**TOPOGRAPHIC MAP**  
**LOT 1D NORTH, THE 480 RANCH SUBDIVISION**  
 LOCATED IN SECTION 12, T6N, R87W, 6TH P.M.,  
 COUNTY OF ROUTT, STATE OF COLORADO

TURCOTTE  
RESIDENCE

TURCOTTE RESIDENCE

JOB NO: 16-067  
DRAWN: BAB  
DATE: 09-10-16

SHEET NUMBER  
**S-1**

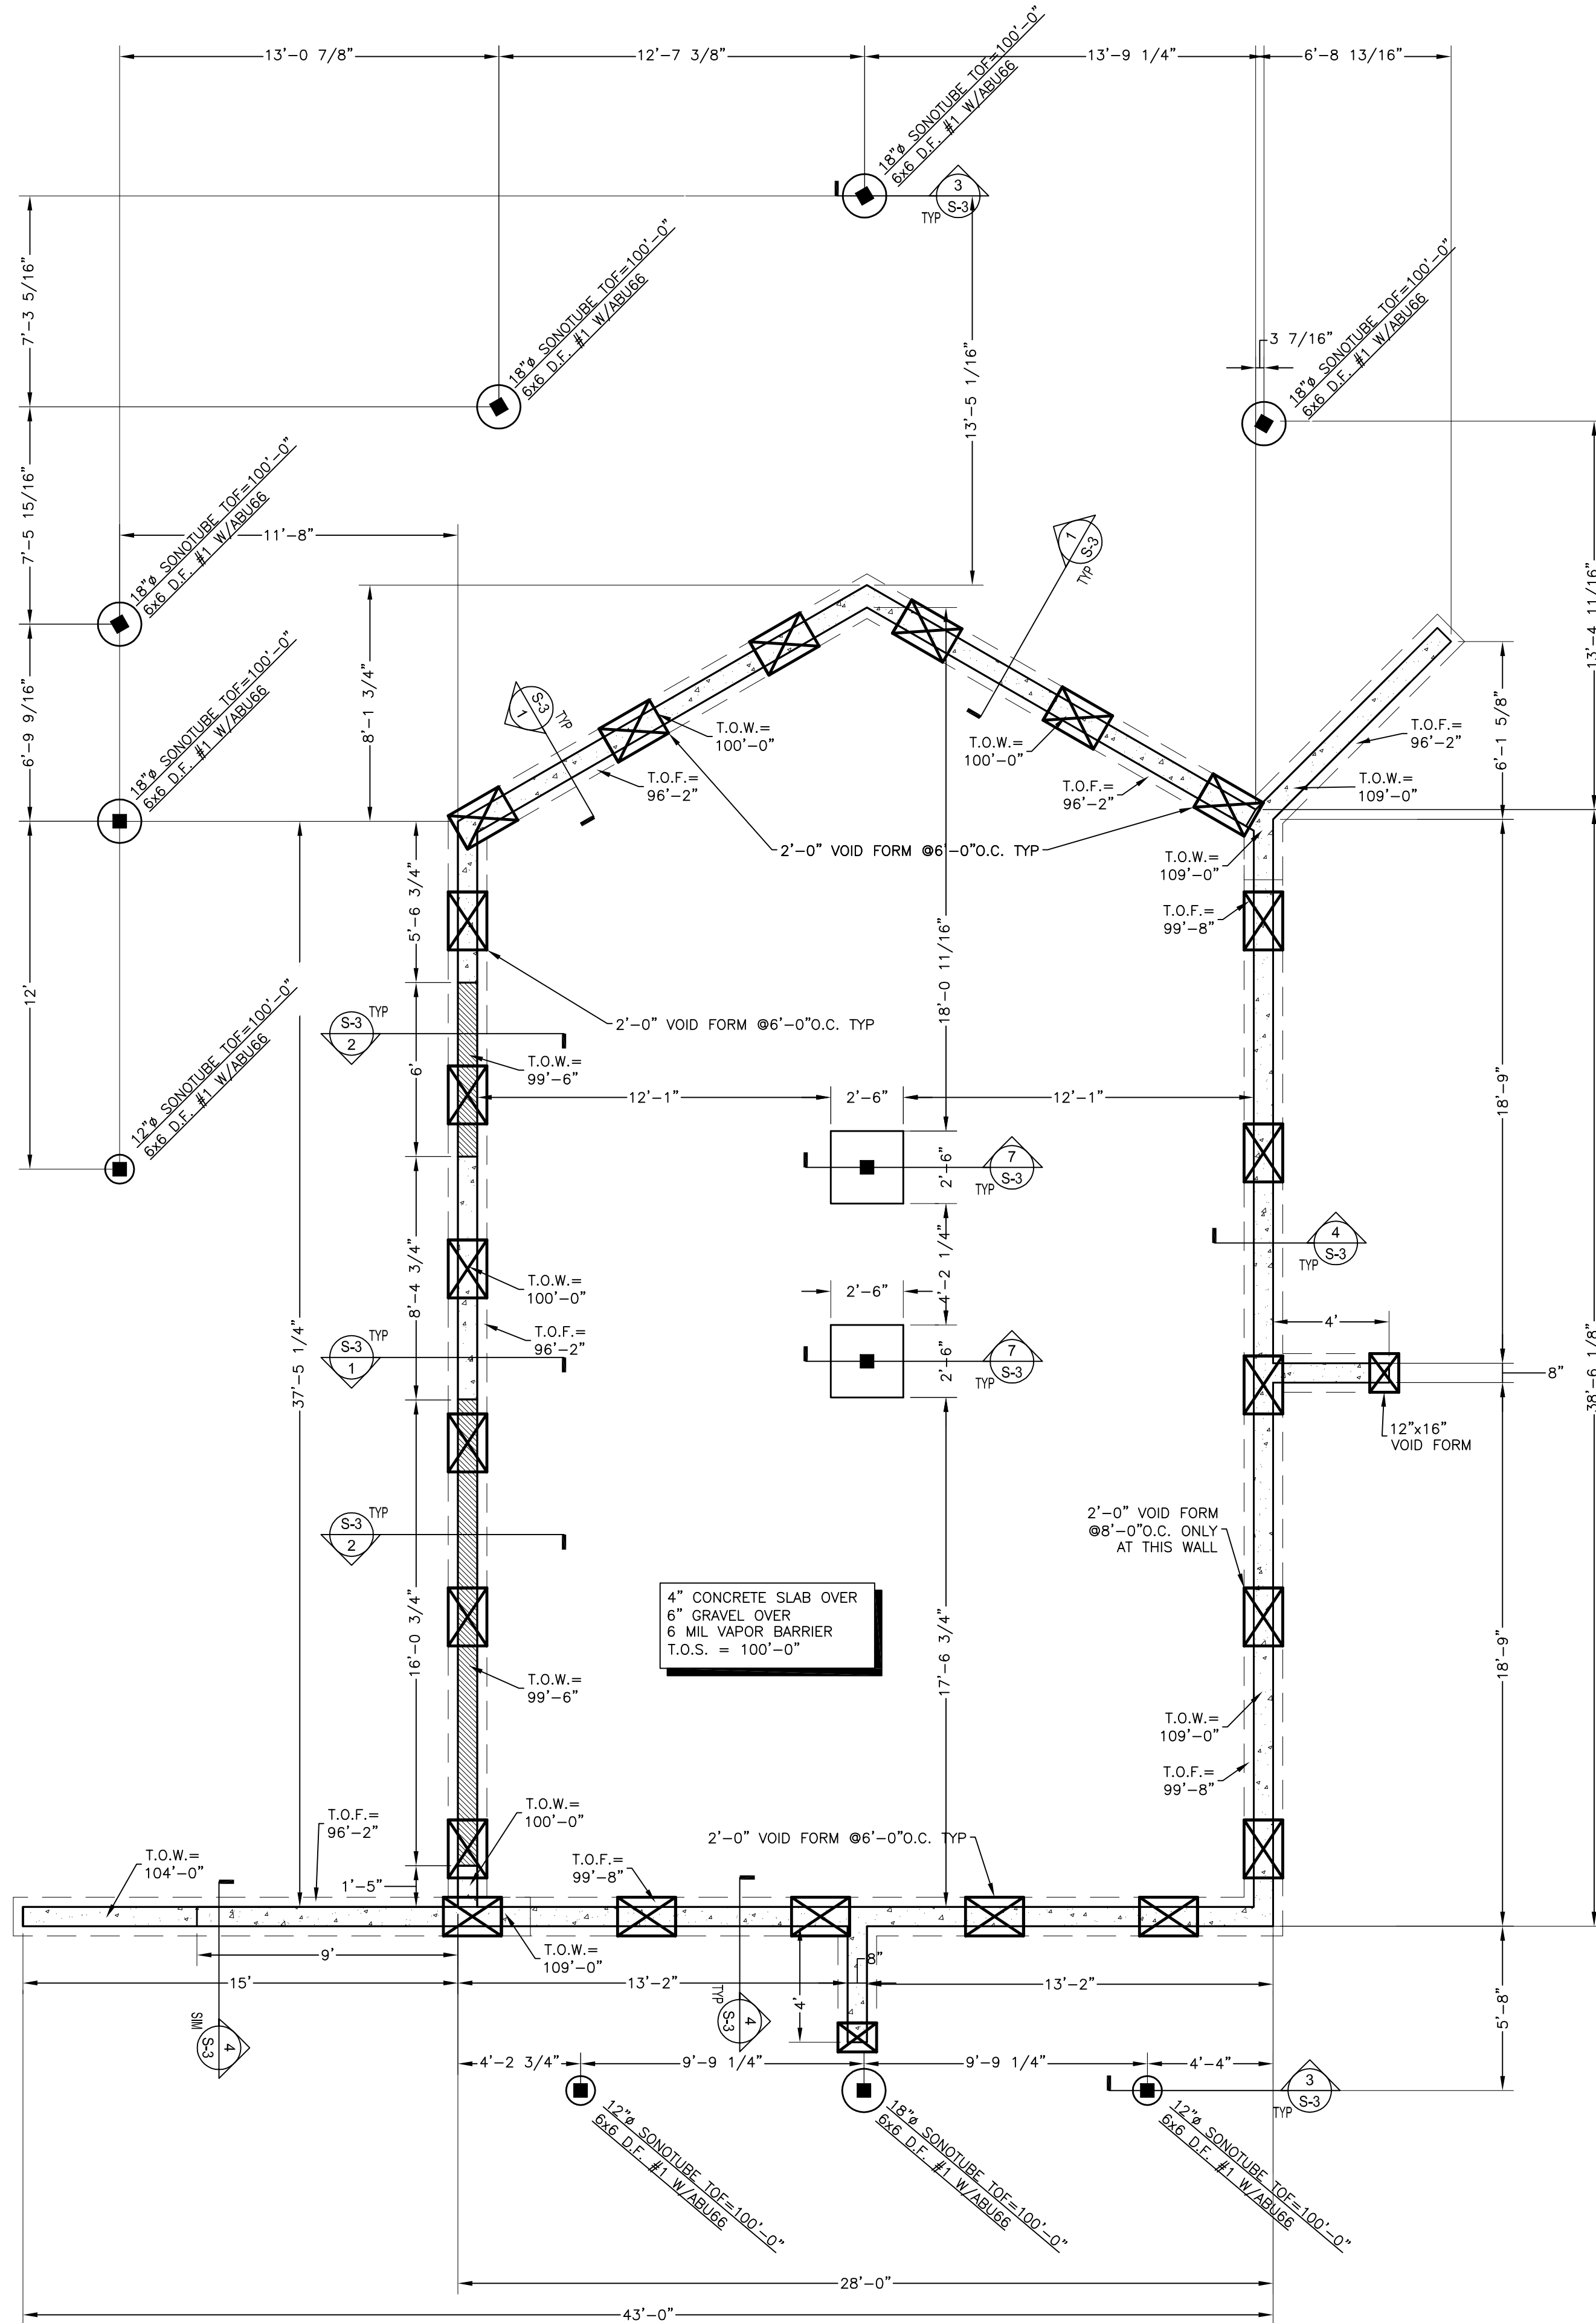
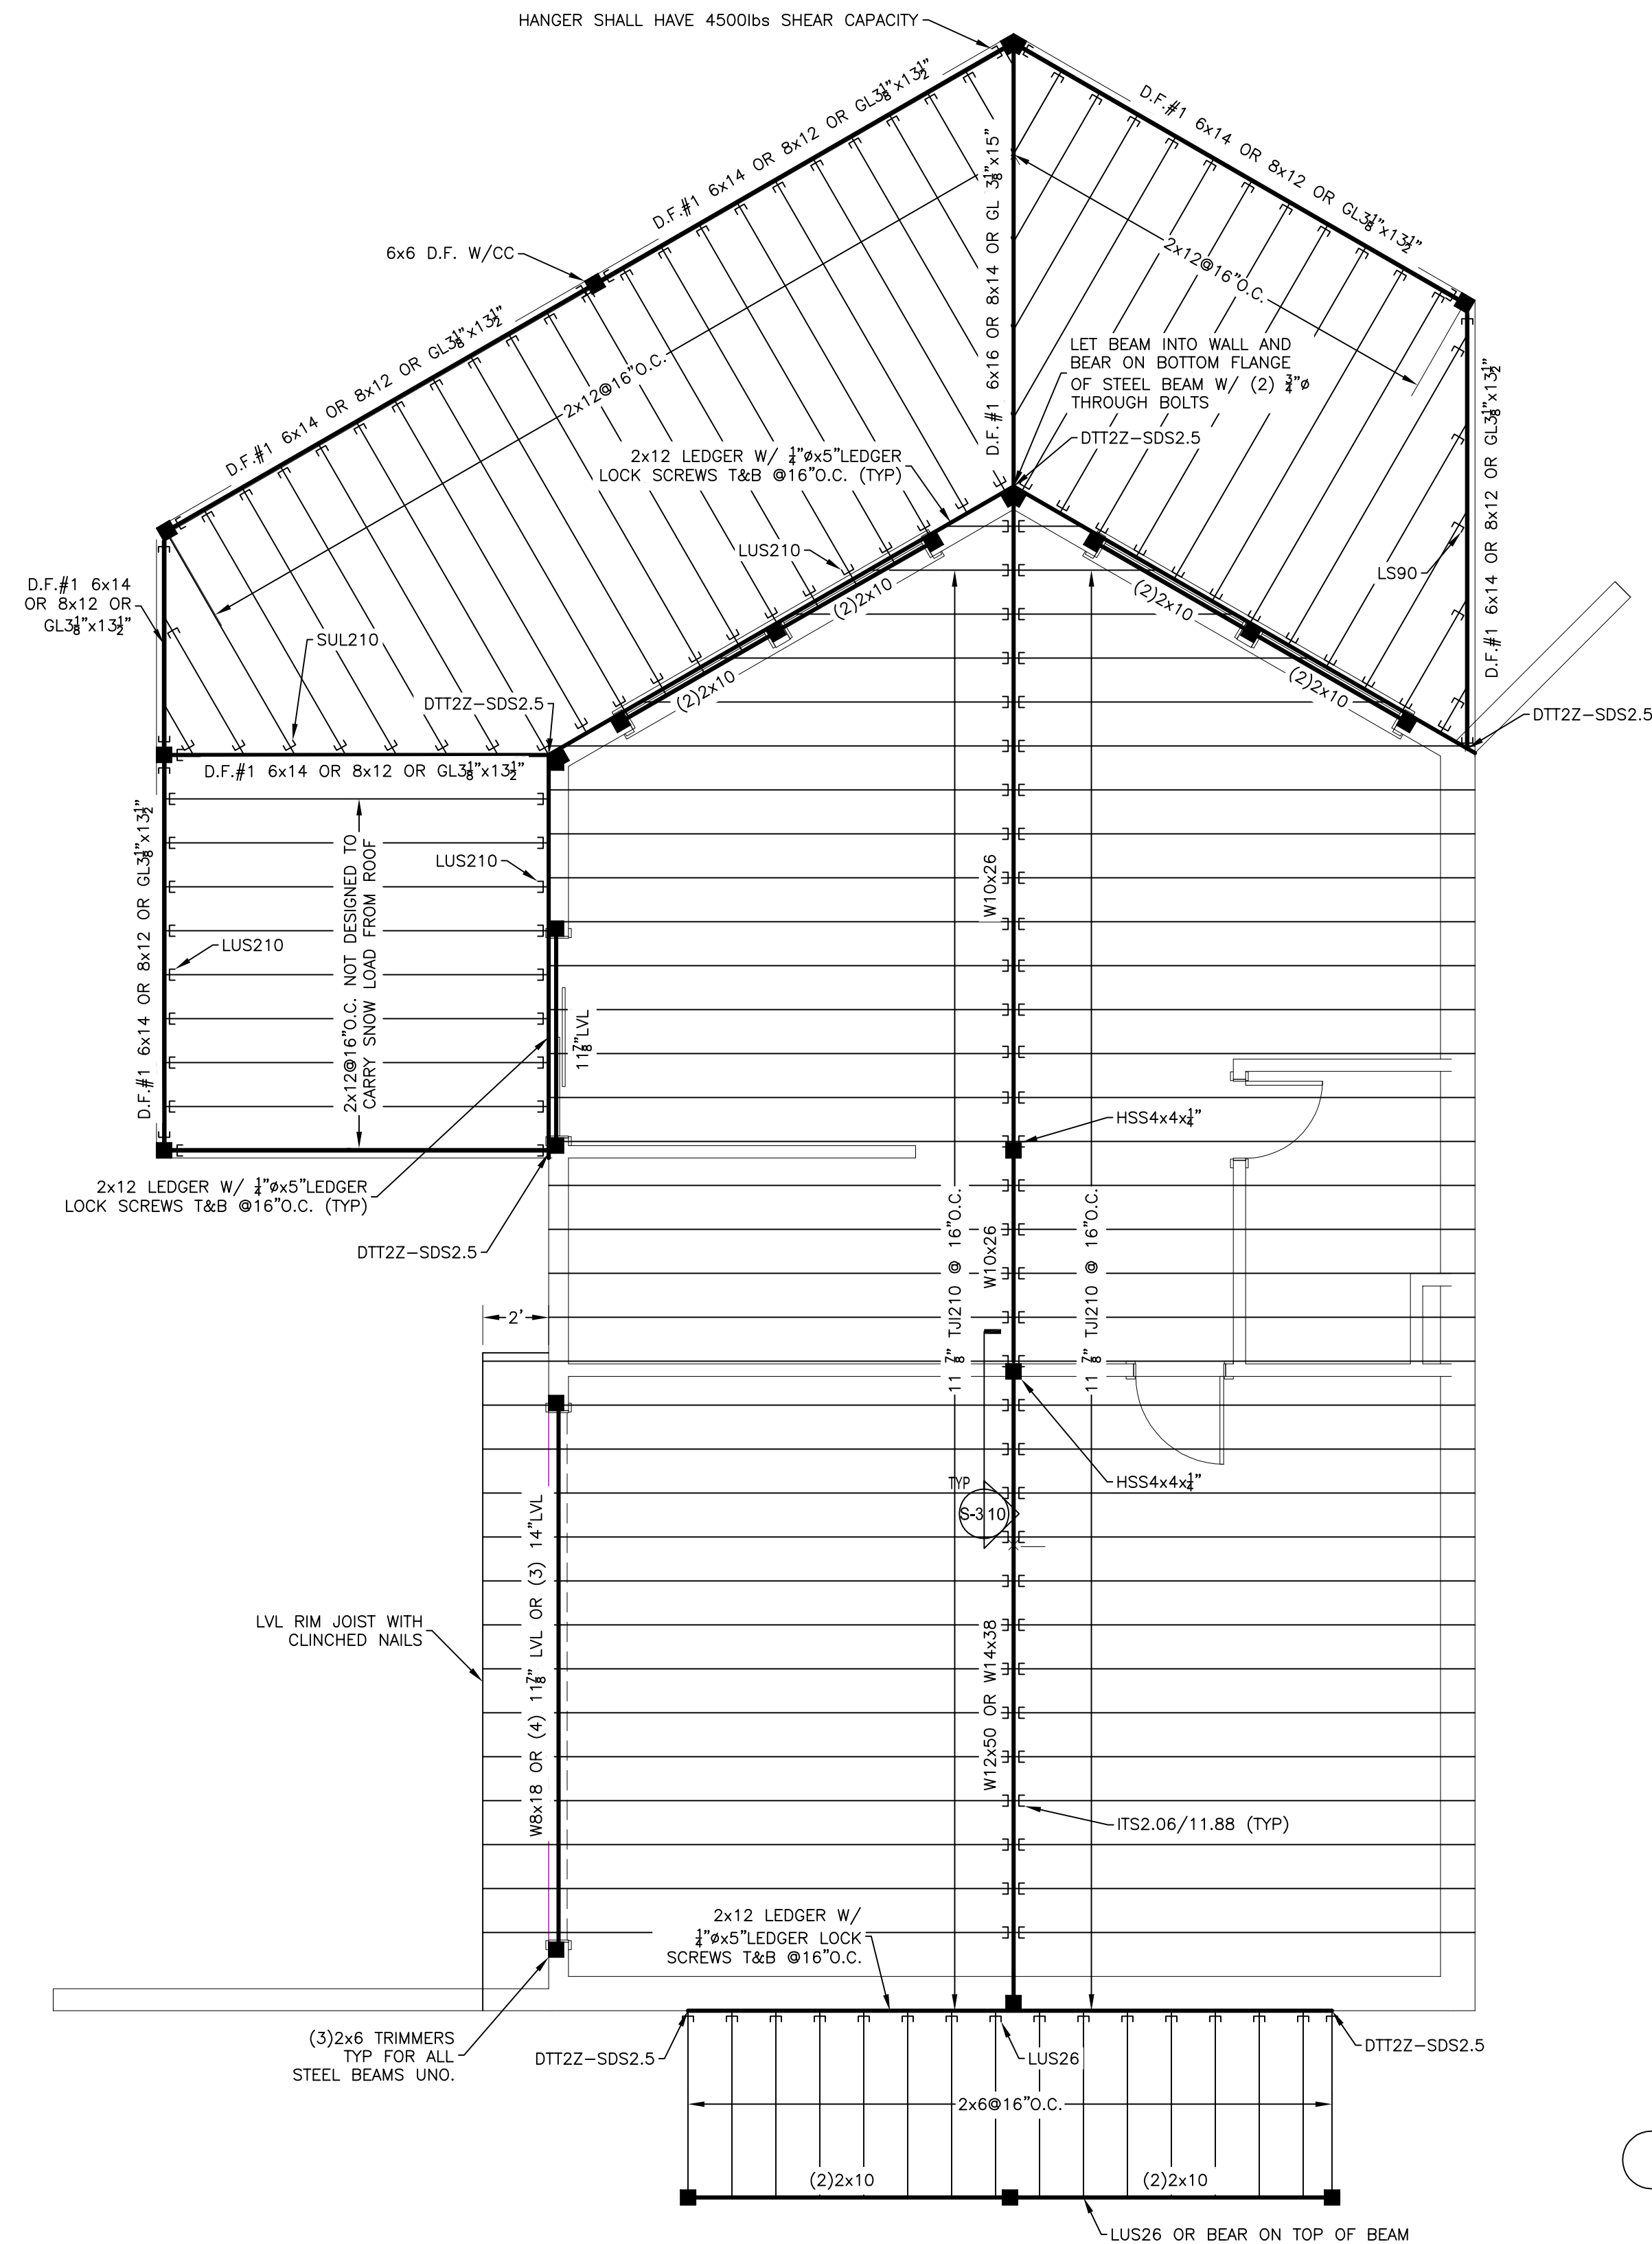
An engineering design shall be submitted for all unconventional framing in accordance with Section R301.1. Show how the tall walls and lateral loads were addressed with the use of exterior and/or interior walls.

Provide electronic copy of Soils Report
